Great Dane Trailers

SERVICE BULLETIN #404

SUBJECT: **BrassCraft 225-6 Street T Pipe Fitting Recall 06V-448**

SERVICE BULLETIN #402

BrassCraft Model 225-6 Street T Pipe Fitting Recall Guide

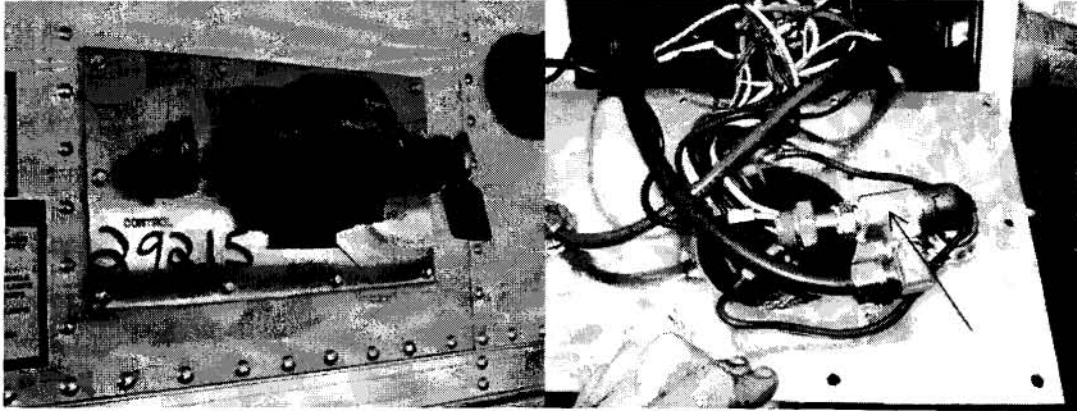
To help you determine whether the pipe fittings in your inventory or installed in your vehicles are the recalled model manufactured by BrassCraft, we are providing below a comparison guide that illustrates the differences between BrassCraft's Model 225-6 fitting and other similar fittings manufactured by other companies, including Parker, Eaton and Anderson.

Only the BrassCraft 225-6 fitting is being recalled at this time.

The BrassCraft 225-6 Street Ts can be uniquely identified by the corner chamfering as seen in the above photograph.

1) Behind Nose Box (When Dome Pressure Switch Is Present)

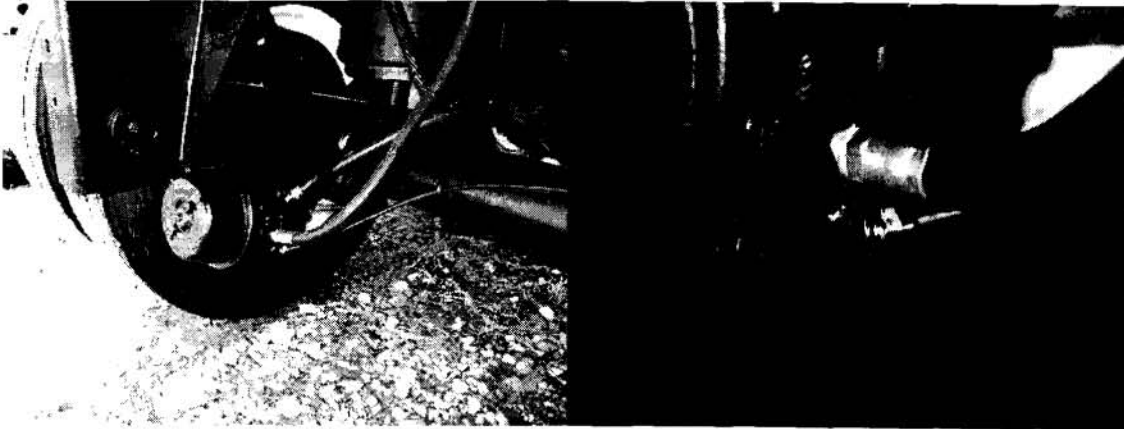
The BrassCraft 225-6 Street T fittings can be installed in several locations. The images below are intended to provide common installation locations. As an additional note, the 225-6 Street Tee fitting is a 3/8" pipe fitting. While additional tee fittings of various sizes may be located on the trailer, only the 225-6 fittings are subject to recall.

- 1) Remove existing Street Tee. This will include the removal of all necessary airbrake hoses/fittings attached to the Street Tee
- 2) All joints to be re-assembled should be prepared with approved thread dope

- 3) Reinstall all airbrake hoses/fittings
- 4) Visually inspect system for complete removal/replacement
- 5) Upon completion of the removal and replacement, a brake system leak check shall be performed consisting of:

- a) Fully charge the air system (typically 125 p.s.i.) and let the system settle (air gauge needle stops moving)
 - b) Time the air pressure drop. The loss rate should not be greater than 2 p.s.i. in one minute

- c) While the system is pressurized, apply soapy water at each replaced fitting and connection and inspect for bubbles indicating a leak
- 6) If leaks are detected, additional tightening may be required or the fitting may need to be replaced.
